NUCLEAR REGULATORY COMMISSION

Title: Advisory Committee on Reactor Safeguards License Renewal Subcommittee

Date: Wednesday, September 5, 2012

CHAIRMAN SHACK: The meeting will now come to order. This is a meeting of the Plant License Renewal Subcommittee. I'm Bill Shack, chairman of the Limerick License Renewal Subcommittee.

Suppression Pool Plate

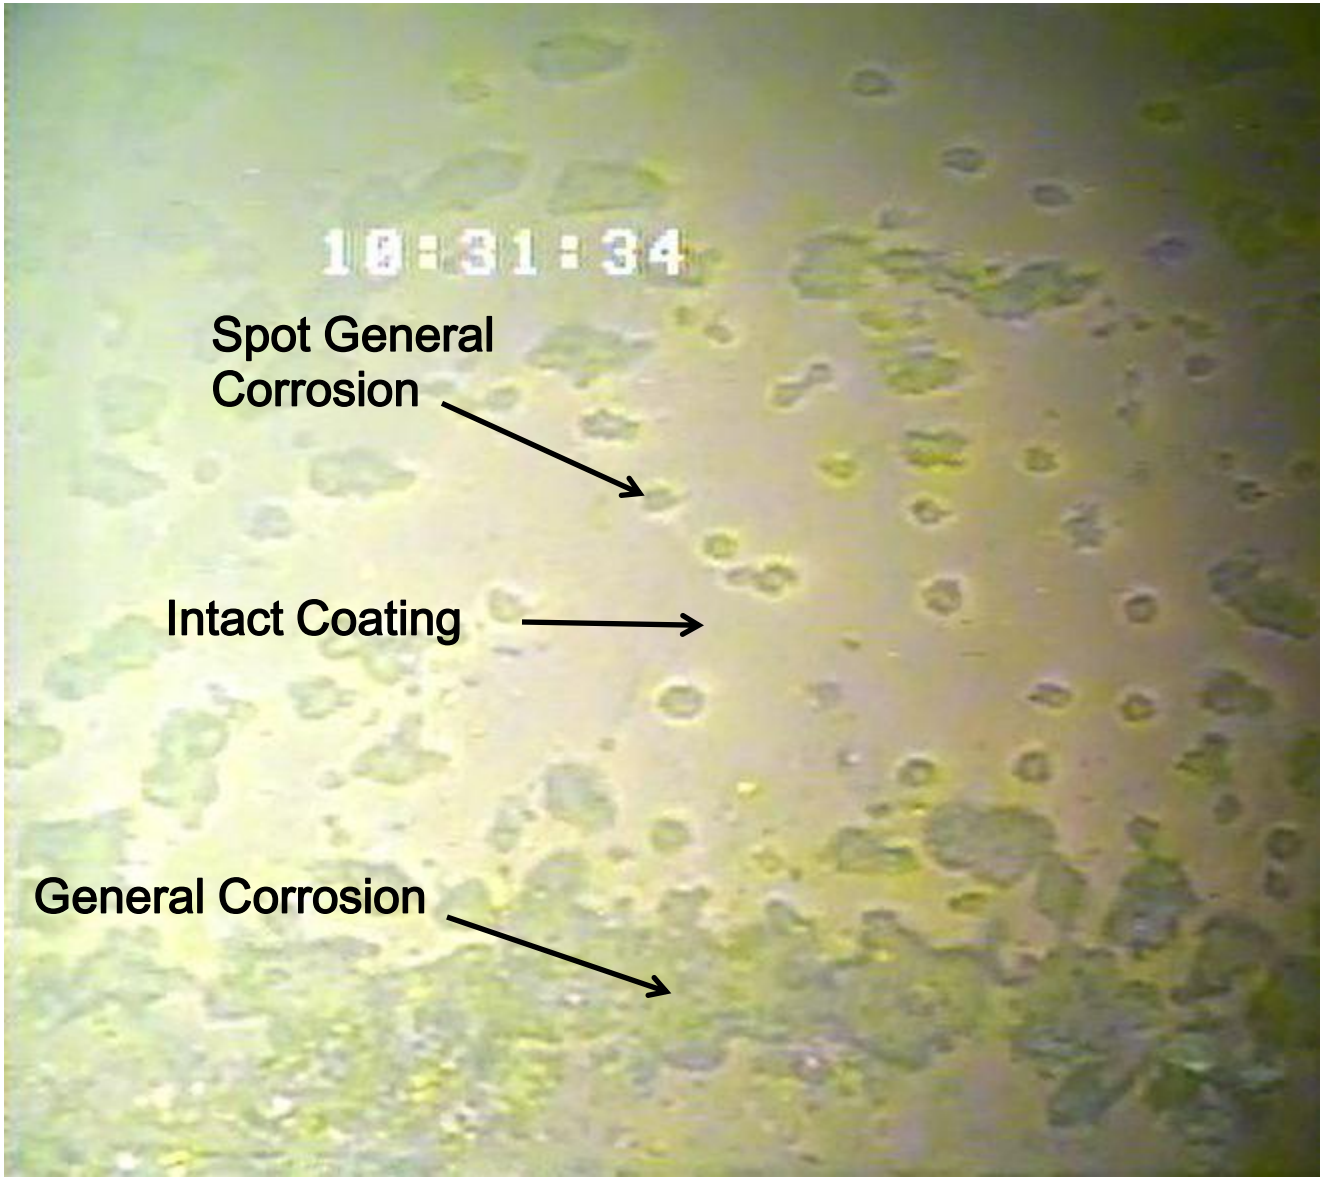
MR. BUDUCK: There are some videos that we do look at. We do have a picture that we will show later on.

CHAIRMAN SHACK: Yes, I mean I saw that picture. The question is really how much of that inspection you're actually able to monitor with the video or is it just a picture of a, you know, a

MR. GALLAGHER: The oversight we do do is there is a live video that's occurring during the outage. And we have people that can look at the video and do. I'm not saying we're there the entire time but there is some oversight. And we verify that the contractor is doing his work in accordance with the contract.

MR. GALLAGHER: And we have some pictures here we can show you. And they're right from the video that the diver is -- from his helmet cam.

Suppression Pool Floor Plan

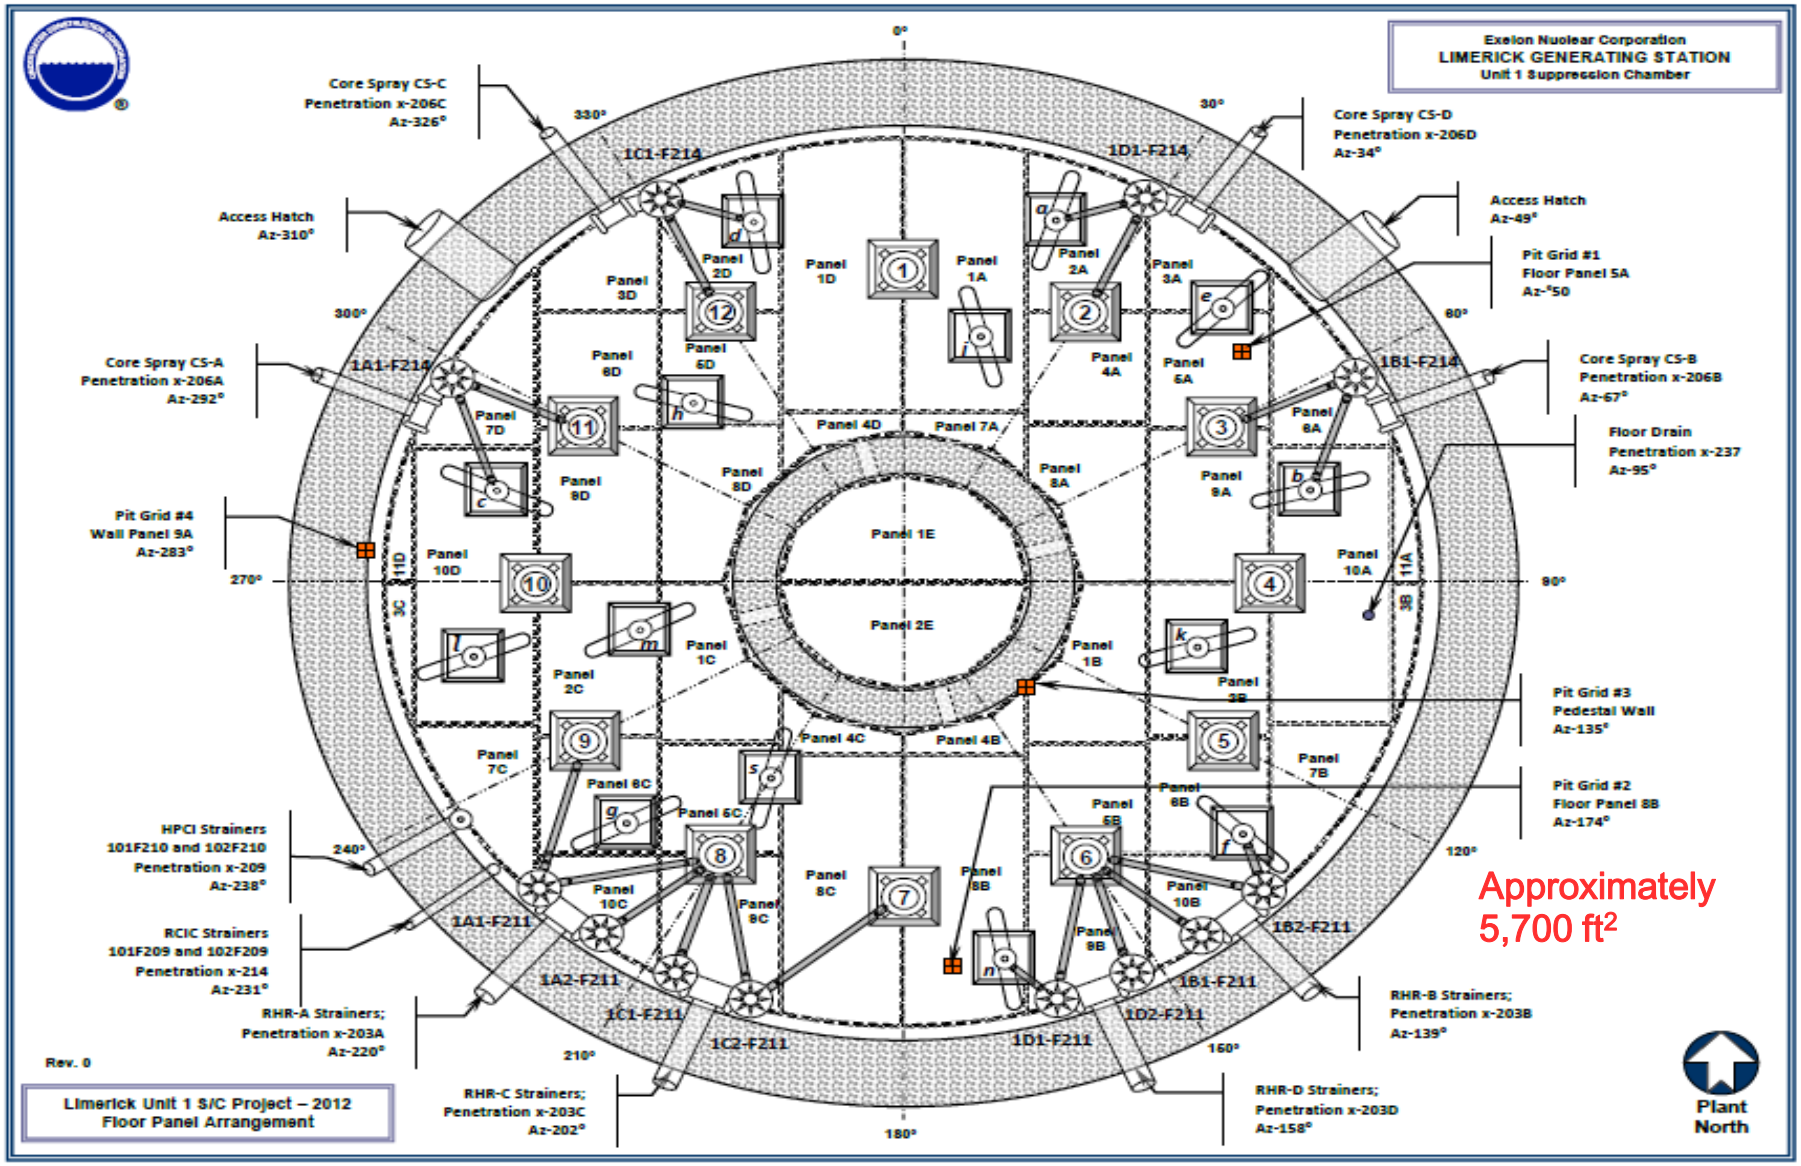
MEMBER STETKAR: You know, a picture of vertical, horizontal surfaces that show what they are.

MR. GALLAGHER: No, Mr. Stetkar. The only thing I can show you, if we go to page 30, slide 30. This is an overview of the floor plan.

Mockup – Wall Panel

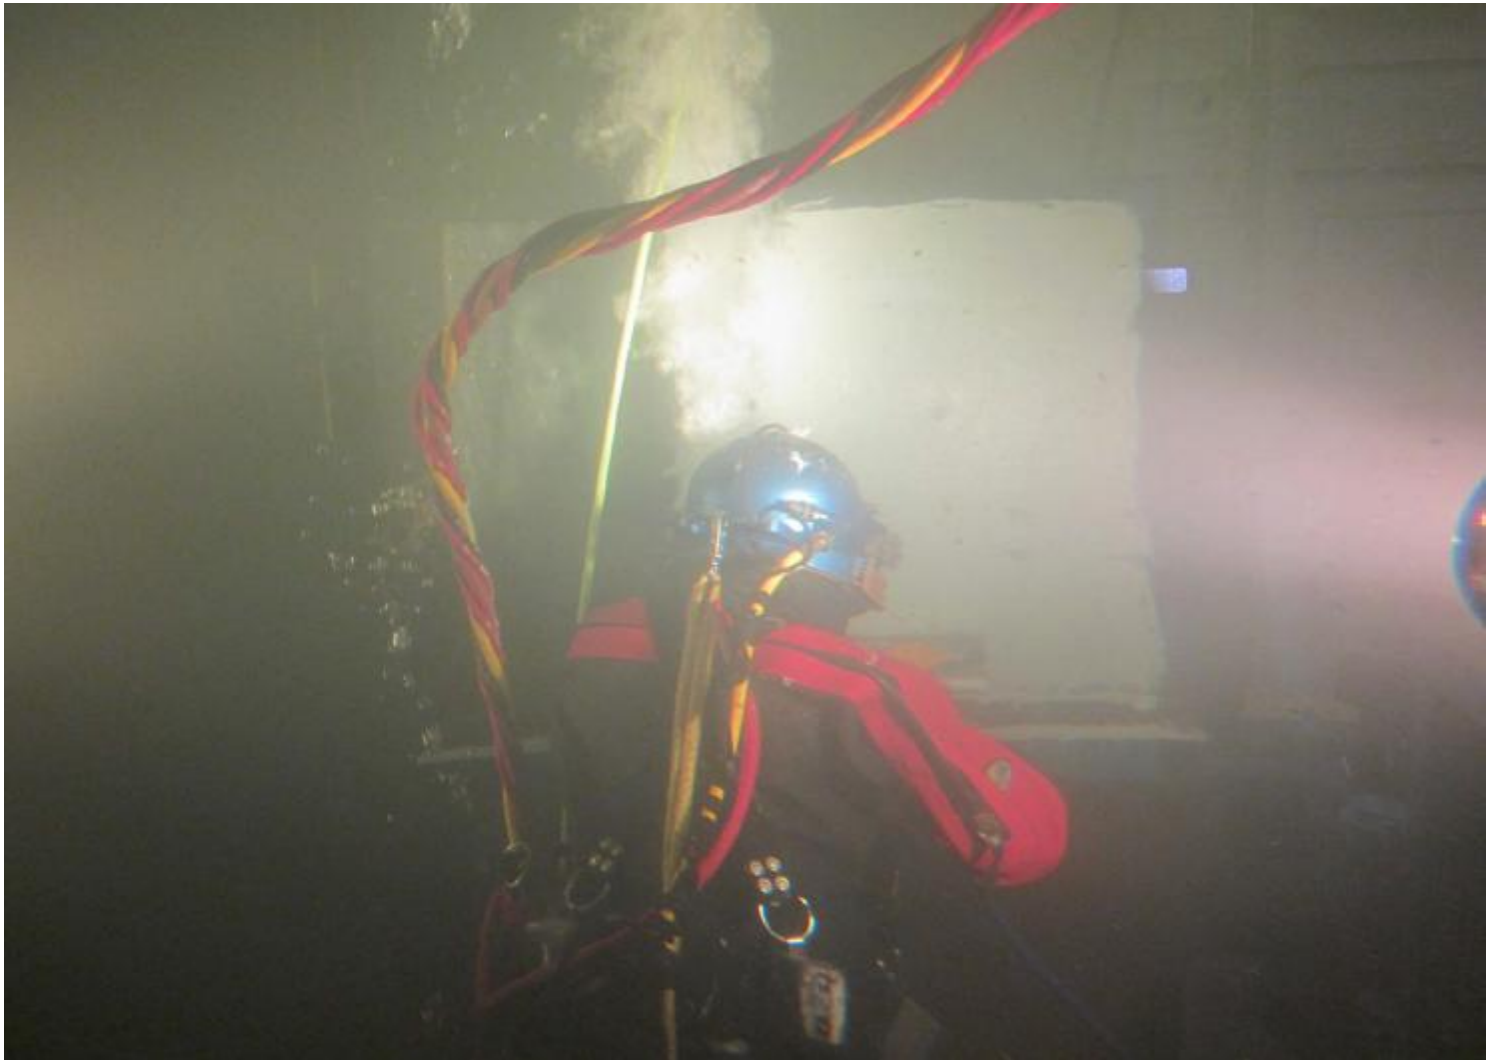
MEMBER STETKAR: Mark, before you sit down is there any experience -- I mean, you know, these photographs show that you have some confidence that you can apply it fairly well. Is there any operating experience either from the nuclear fleet and the answer there is probably not yet, but from perhaps maritime applications if it's indeed used in maritime applications to give you confidence that indeed the coating remains intact and is effective for periods like 10 to 15 to 20 years? Is there any evidence to support that?

MR. GALLAGHER: Yes, it's a backup. And we'll show you this. This is 43, a vertical plate that was done in a mockup and then look at 44. Can we go to 44, Chris? Did a configuration of floor with various configurations. And you know, so the process is set up to be performed underwater, cleaning the application. You know, it's a multi-coat system that's applied.
